**STAFF RECOMMENDATION**  
**3926 Cambridge Avenue**  
**July 19, 2017**

**Application:** New construction—addition and outbuilding  
**District:** Cherokee Park Neighborhood Conservation Zoning Overlay  
**Council District:** 24  
**Map and Parcel Number:** 10308018400  
**Applicant:** Van Pond, Jr.  
**Project Lead:** Melissa Baldock, melissa.baldock@nashville.gov

DATE OF ISSUANCE:  
 1 July 2017  
 PROPOSED SITE PLAN

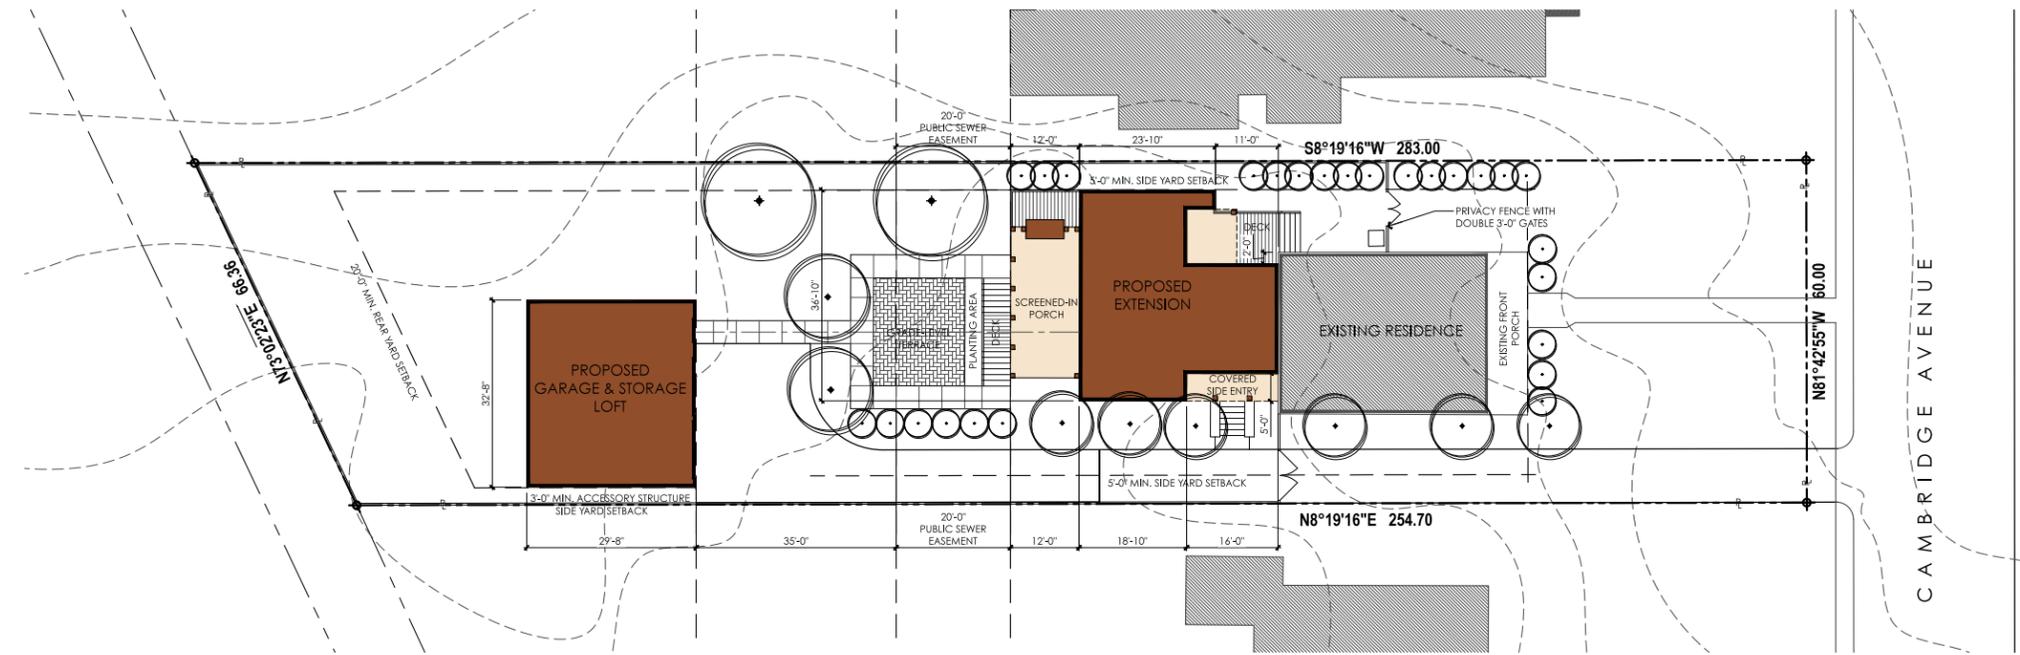
Setback & Rhythm of Spacing: The addition meets all base zoning setbacks. It will be five feet (5') from the right side property line and approximately eighteen feet (18') from the left side property line. It will be over one hundred and twenty feet (120') from the rear property line. The wider and taller portion of the addition will be highly visible from the street, but because it is set back from front of the house, it will not have a significant impact on the rhythm of spacing of houses along the street. Staff finds that the addition's setback and rhythm of spacing meet Sections II.B.1.c. and II.B.2. of the design guidelines.

\*Base zoning and MHZC policy require that outbuildings that have a footprint larger than seven hundred square feet (700 sq. ft.), like this one, be a minimum of five feet (5') from the side property lines. Staff finds that the proposed three foot (3') side setback does not meet Section II.B.h.2 of the design guidelines.

① South Elevation (Cambridge Avenue)  
 SCALE 1/4" = 1'-0"

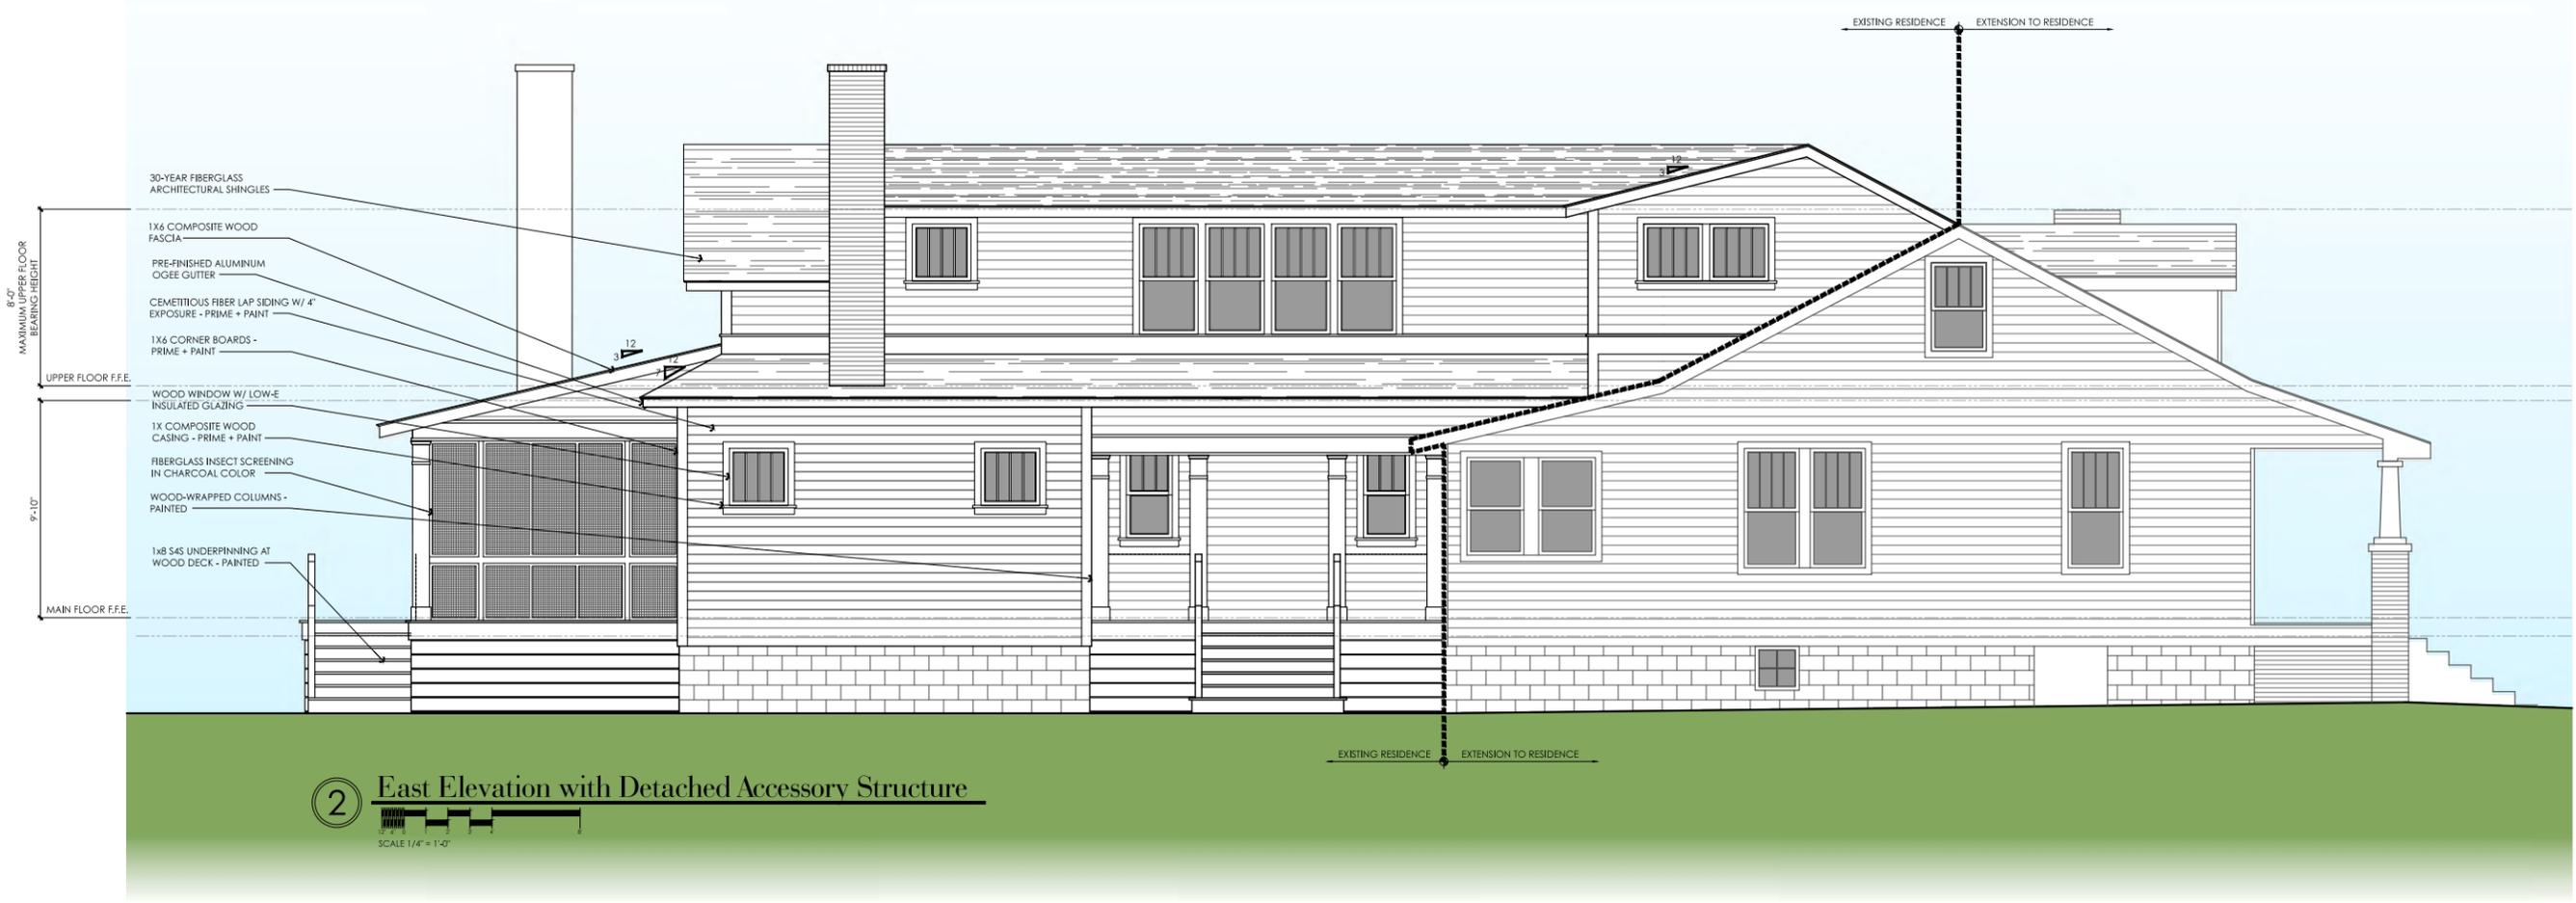
Height & Scale: The proposed addition includes a ridge raise. The ridge raise will be inset two feet (2') from the side walls of the historic house, which meets the design guidelines. However, it will increase the roof by three feet, seven inches (3'7") vertically. The design guidelines state that *"The purpose of a ridge raise is to allow for conditioned space in the attic and to discourage large rear or side additions. The raised portion must sit in a minimum of 2' from each side wall and can be raised no more than 2' of total vertical height within the same plane as the front roof slope."* The design guidelines do not allow for ridge raises that increase the height of the roof more than two feet (2'), and therefore the proposed three foot, seven inch (3'7") ridge raise does not meet the design guidelines. In addition, the ridge raise is problematic because it does not serve to discourage a large rear and side addition. Ridge raises greater than two-feet (2') have not been approved for historic buildings.

The rear addition will be both taller and wider than the historic house. An addition that is wider than the historic house could be appropriate in this instance because the lot is sixty feet (60') wide and because the house is relatively narrow at just twenty-nine feet (29'). However, the design guidelines state that *"In these cases, an addition may rise above or extend wider than the existing building; however, generally the addition should not higher and extend wider."* Staff finds the portion of the addition that is eight feet (8') wider than the historic house and three feet, seven inches (3'7") taller than the historic house to be inappropriate. It does not meet the design guidelines.

Roof form: As discussed under “Height and Scale,” the proposed ridge raise does not meet the design guidelines because it increases the height of the roof by more than two feet (2’) vertically. The portion of the addition that is both taller and wider than the historic house includes a wall dormer, which does not meet the design guidelines. The design guidelines state that front-facing and side dormers should be inset two feet (2’) from the wall below. Staff finds that because of the tall ridge raise and the front-facing wall dormer, the proposed roof form does not meet Sections II.B.1.e. and II.B.2. of the design guidelines.

① **Detached Accessory Structure North Elevation (Front)**  
SCALE 1/4" = 1'-0"

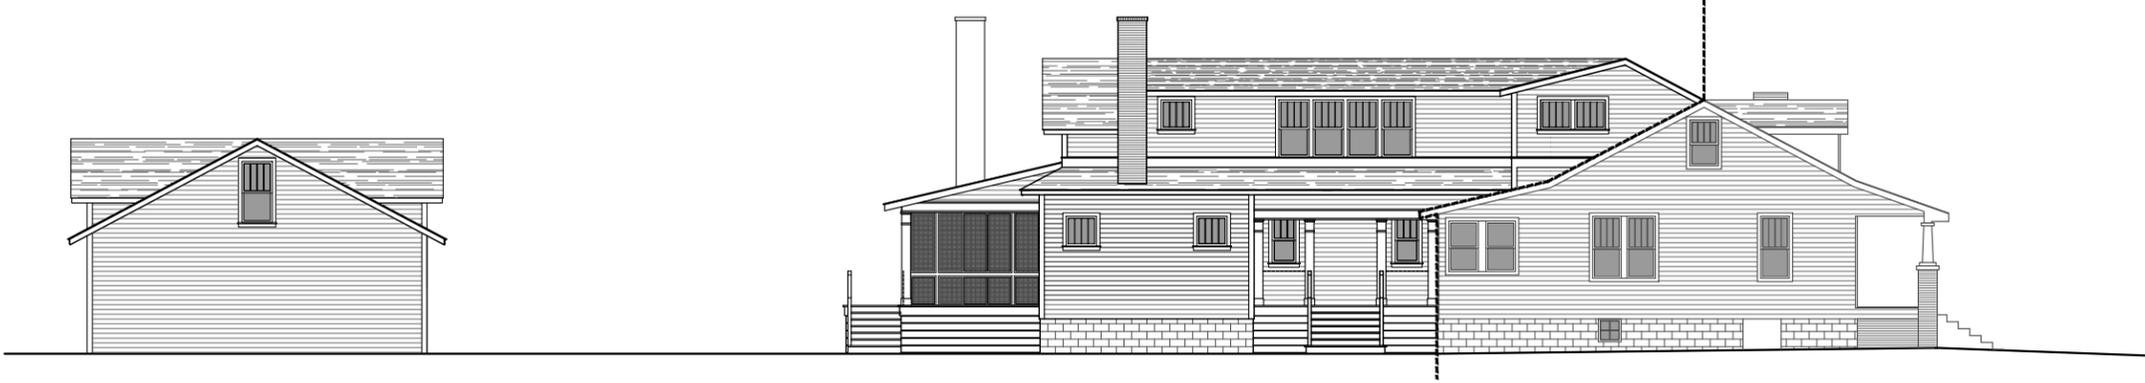
\*The dormers stack on the wall below. Because they are not inset two feet (2’) from the wall below, staff finds that the proposed outbuilding does not meet Section II.B.i.1 of the design guidelines.
